Proposal to improve and correct the text of the three new simplified UN Regulations "LSD", "RID" and "RRD".

The text reproduced below was prepared by the expert from the IWG SLR with the aim to improve and correct some minor errors or inconsistencies identified in the text of the draft new UN Regulations submitted by the SLR to GRE-79, namely documents GRE/2018/02, GRE/2018/03 and GRE/2018/04.

Cover page, amend to read:

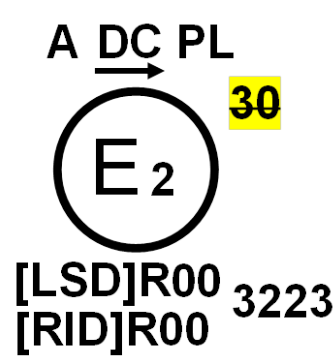
The proposal for a new UN Regulation on **Light Signalling Road Illumination Devices (LSDRID)** reproduced below was prepared by the IWG SLR on the basis of informal document GRE-78-31 and taking into account the input received during the 78th GRE session. Some text is shown in square brackets to indicate that consideration and a decision are required. "
